## City of Maple Plain

### Request by North Shore Gymnastics for Site Plan Review, Preliminary Plat and Final Plat to Allow a New Building and Associated Site Plan Improvements for the Properties Located at 5380 and 5480 Pioneer Creek Drive

*To:* City Council  
*From:* Mark Kaltsas, City Planner  
*Meeting Date:* December 15, 2025  
*Applicant:* North Shore Gymnastics  
*Owner:* North Shore Gymnastics  
*Location:* 5380 and 5480 Pioneer Creek Drive

LANDSCAPE  
PLAN

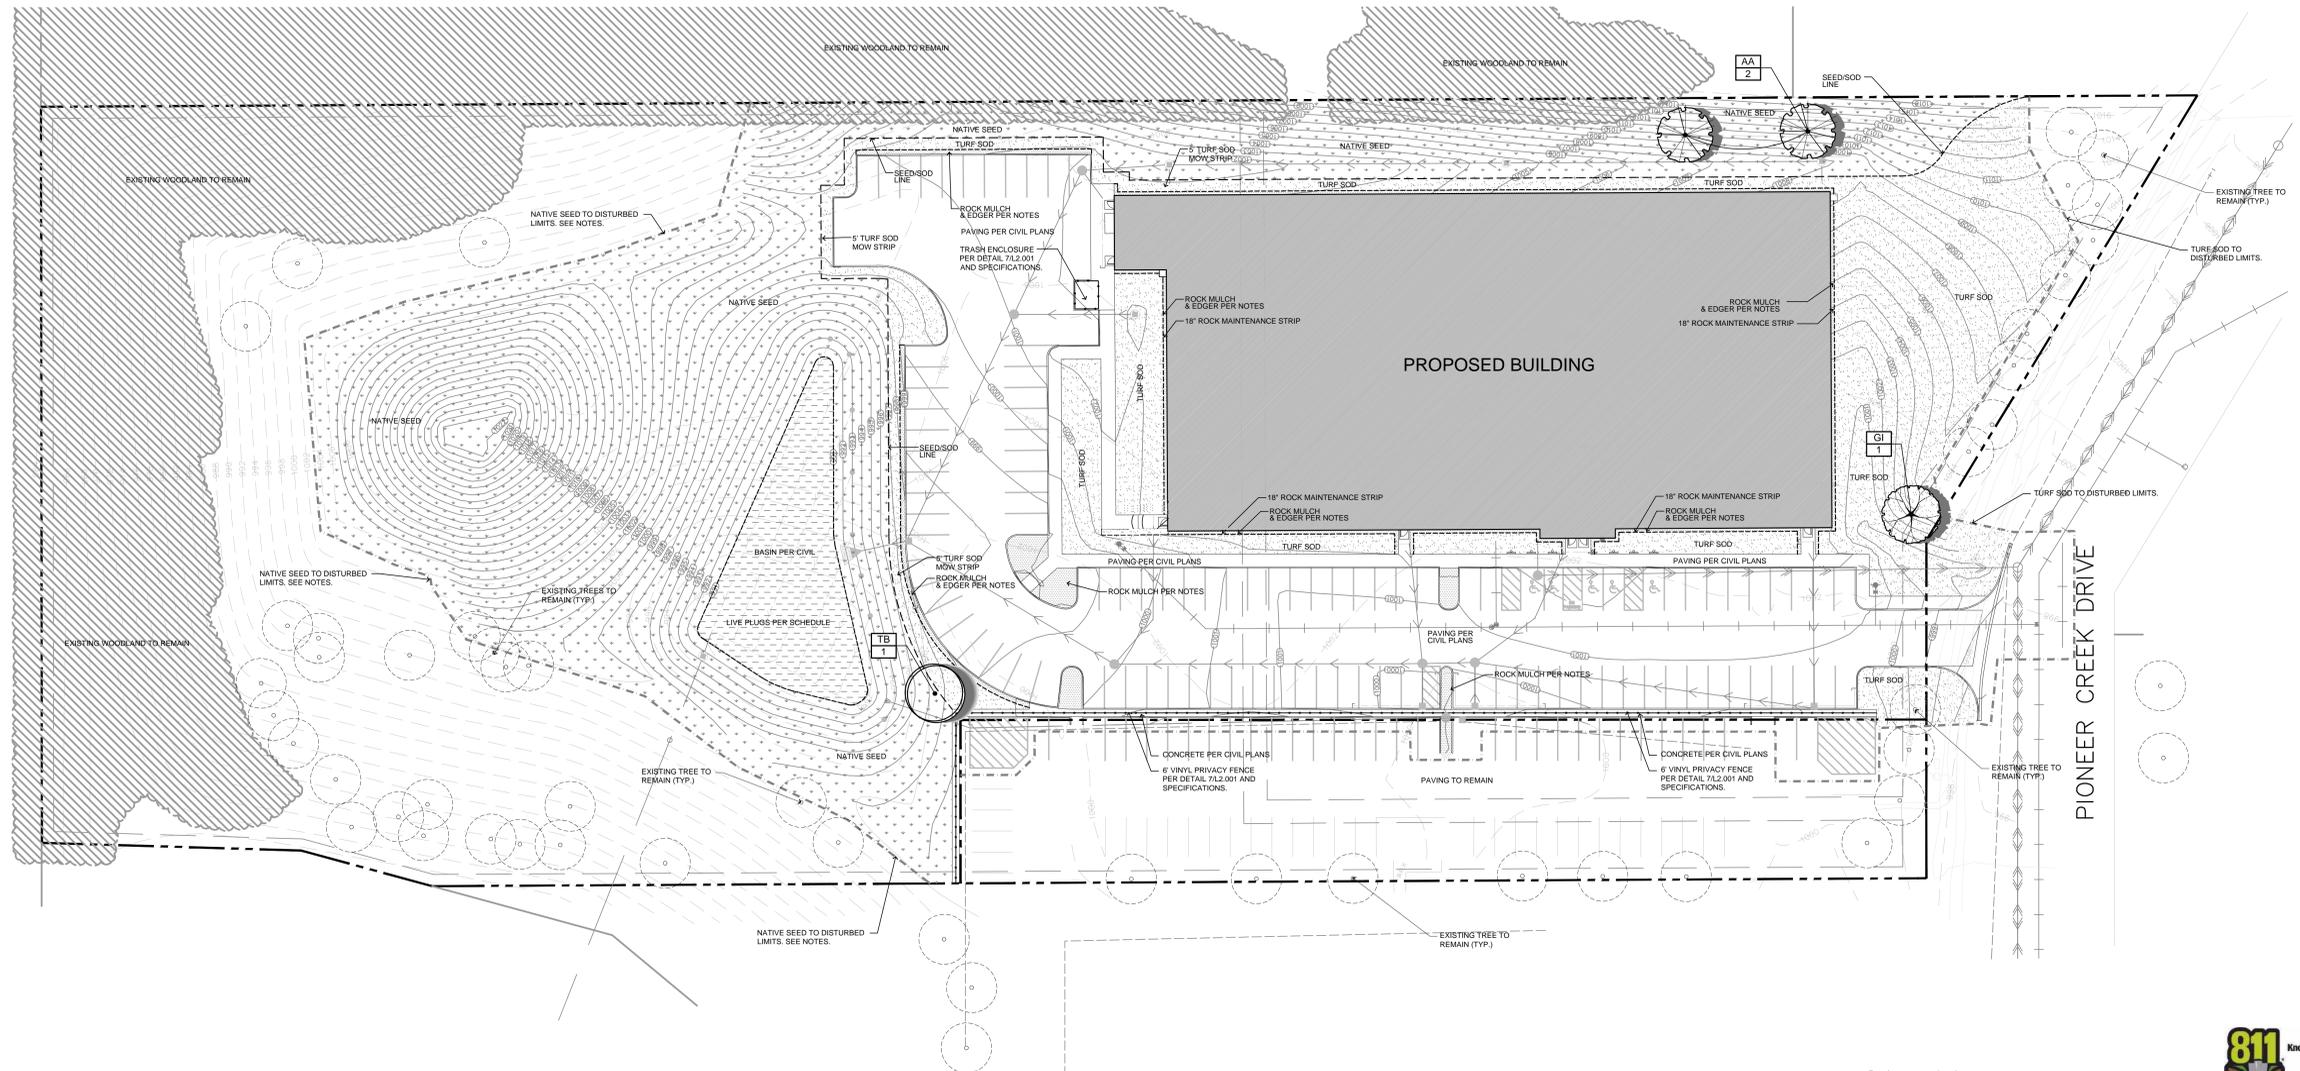
The applicant has revised the landscape plan based on the changes to the site grading. The applicant is now proposing to preserve the majority of existing trees located along Pioneer Creek Drive. This will maintain a significant planting along the south side of the proposed building. The applicant has also revised the planting around the building perimeter. The city will be seeking direction from the Planning Commission relating to the proposed landscape plan.

- b. The Applicant shall provide additional landscape as directed by the Planning Commission along the west building elevation at the front entrance and within the two interior parking lot landscape islands. The applicant shall submit a revised landscape plan to the City for review and approval.

- b. The Applicant shall provide additional landscape as directed by the Planning Commission along the west building elevation at the front entrance and within the two interior parking lot landscape islands. The applicant shall submit a revised landscape plan to the City for review and approval.
